AMPC CAPITAL SHOPPING CENTRES	
APPROVED DESIGN CONCEPT	
DATE: 20/01/10	ISSUE: P 3/13
CLIENT: Warringah	
SHOP NAME: FMT	
DESIGN: [Signature]	
The concept is granted to the lessee for the shop layout and signage shown on these drawings. A copy of the concept is to be submitted and if requested submitted for approval.	
SUBJECT TO AMENDMENTS

HORIZON DESIGN STUDIO Interior Design Graphic Design	1309, Batek Building, 200 Cole St Brockvale, NSW 2100, Australia t 61 2 9939 9866 f 61 2 9939 0377 e hds1309@bigpond.com hds1309.com.au	CLIENT: FMT MESSAGE		PROJECT: SHOP 317 WARRINGAH MALL SHOPPING CENTRE		DRAWING TITLE: SHOPFRONT ELEVATION		B A	230310 220310	ALL DIMENSIONS TO BE CHECKED ON SITE PRIOR TO WORK COMMENCEMENT. ALL DIMENSIONS SHOWN TO BE TAKEN IN PREFERENCE TO SCALE. THESE DRAWINGS SHALL REMAIN THE COPYRIGHT OF HORIZON DESIGN STUDIO
		DRAWING NO: 03	PROJECT NO:		SCALE: 1:50	CHK:				
					DRW JIMMY Z.	DATE: 30/01/10	ISSUE

SECTION A

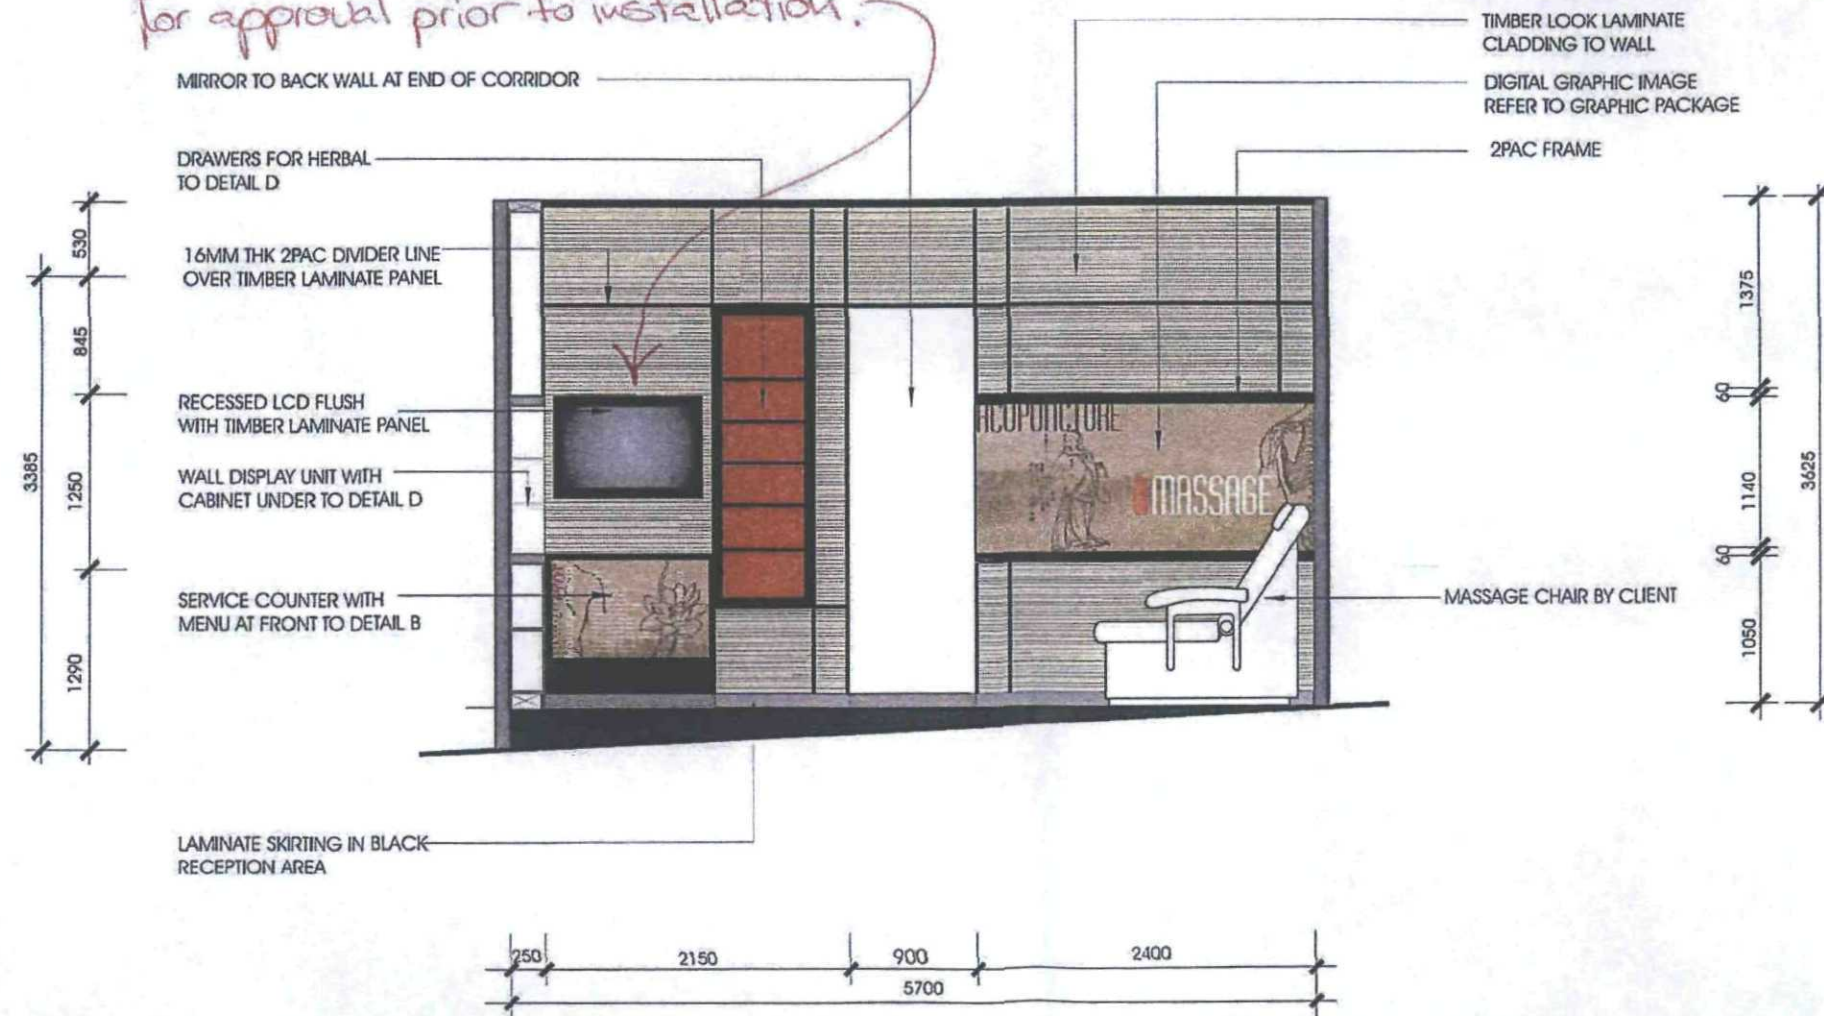
Require content that will be played on plasma screen to be submitted on DVD for approval prior to installation.

E. WALL DISPLAY DETAIL

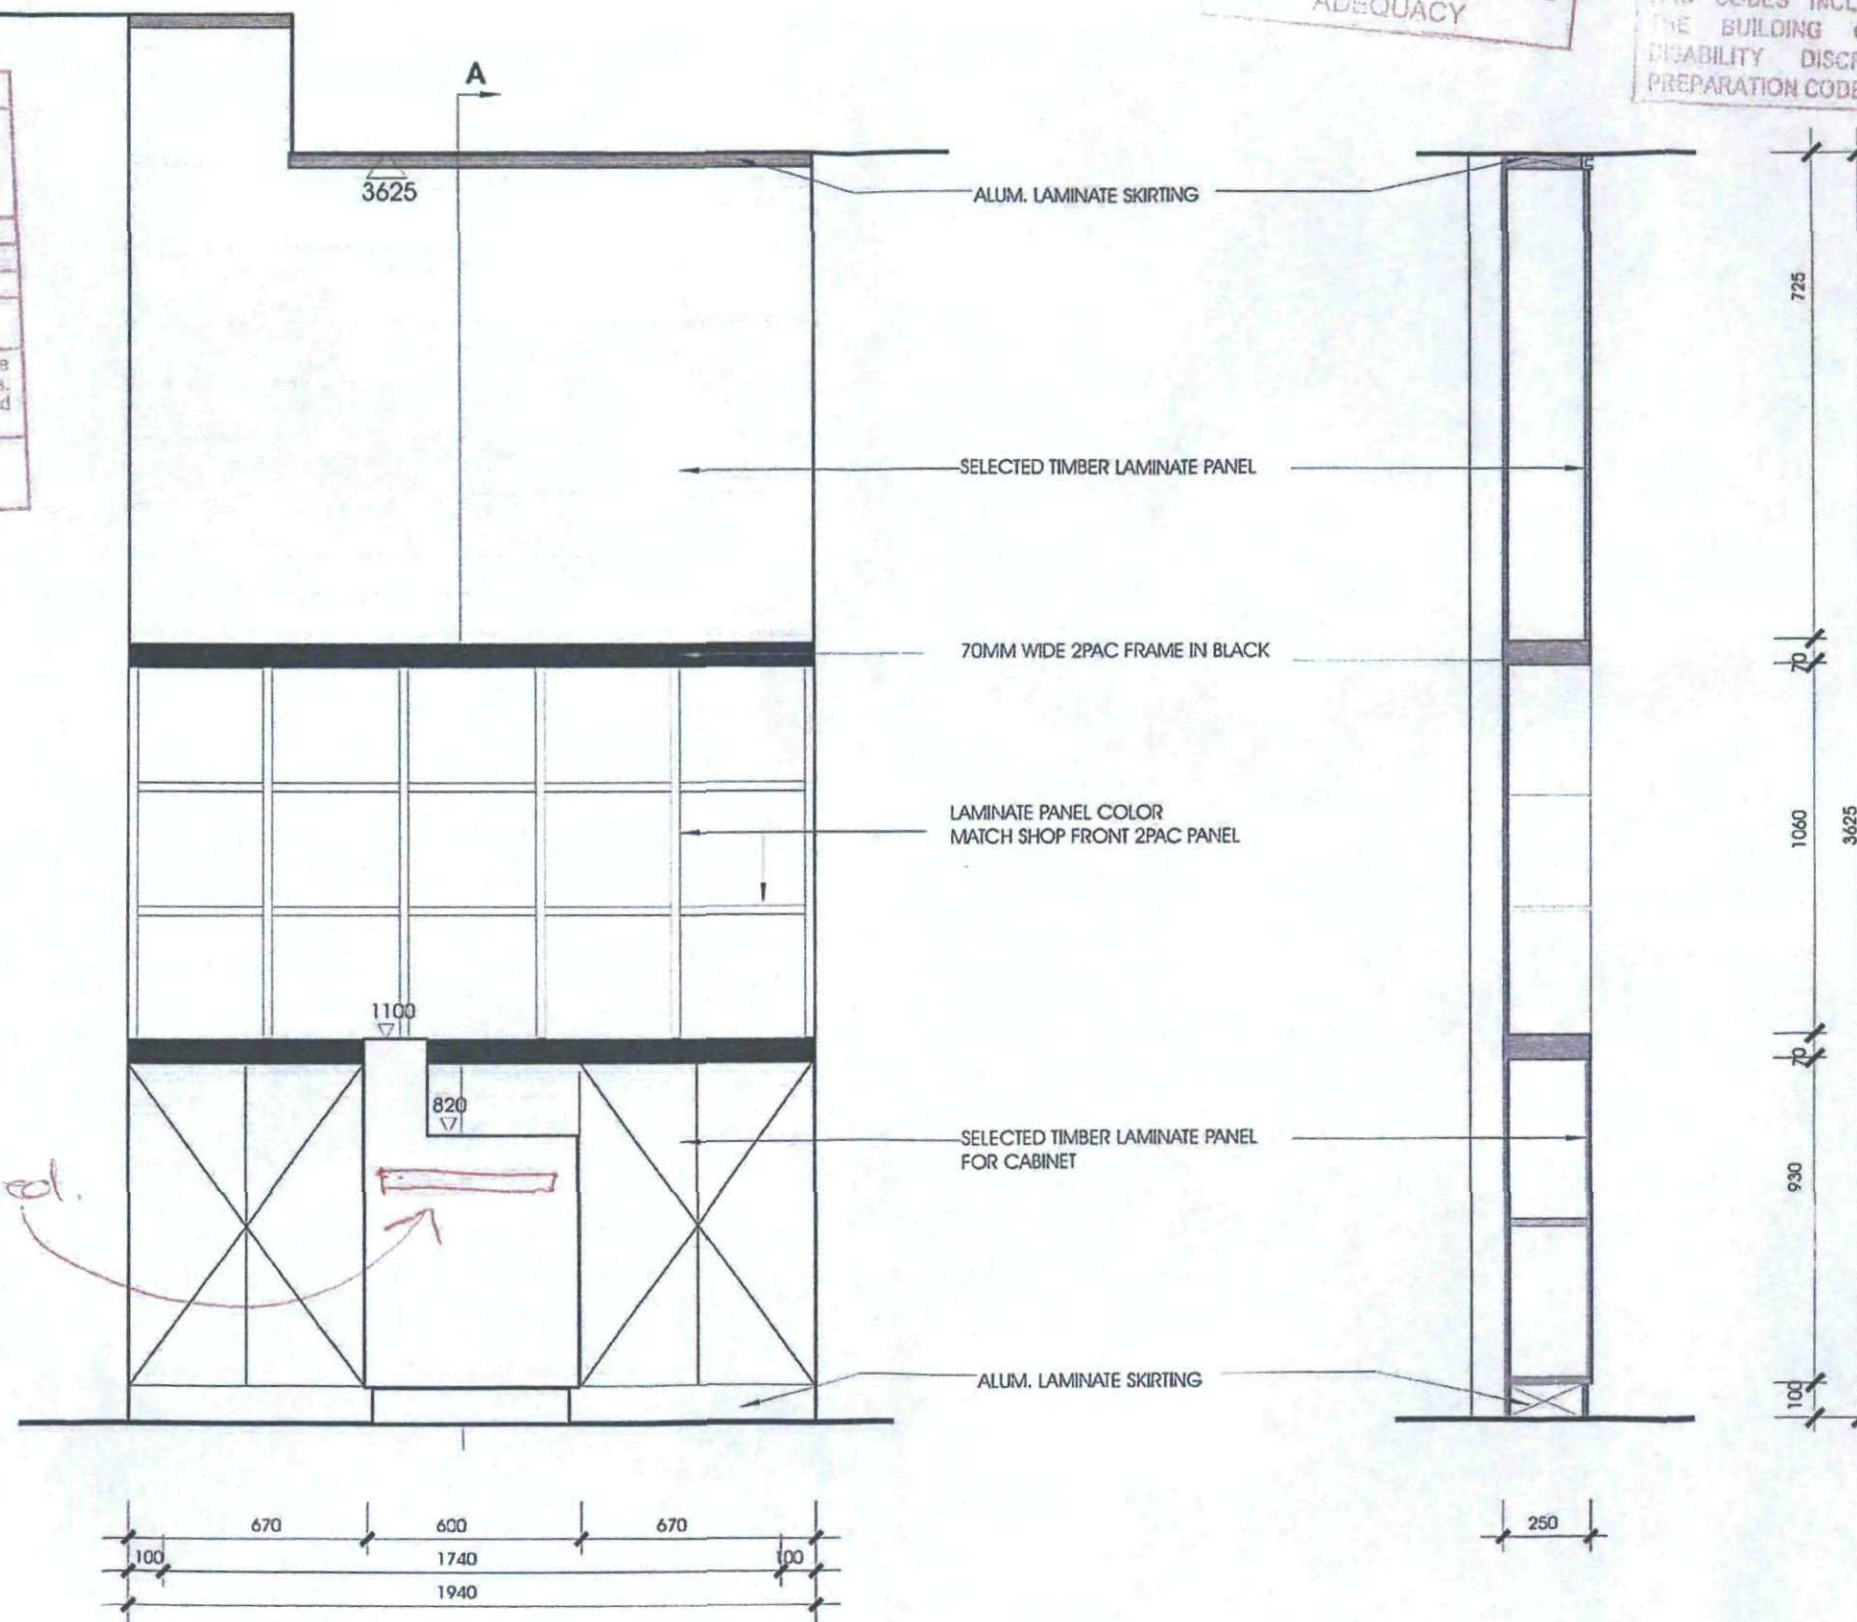
DDA niche required.
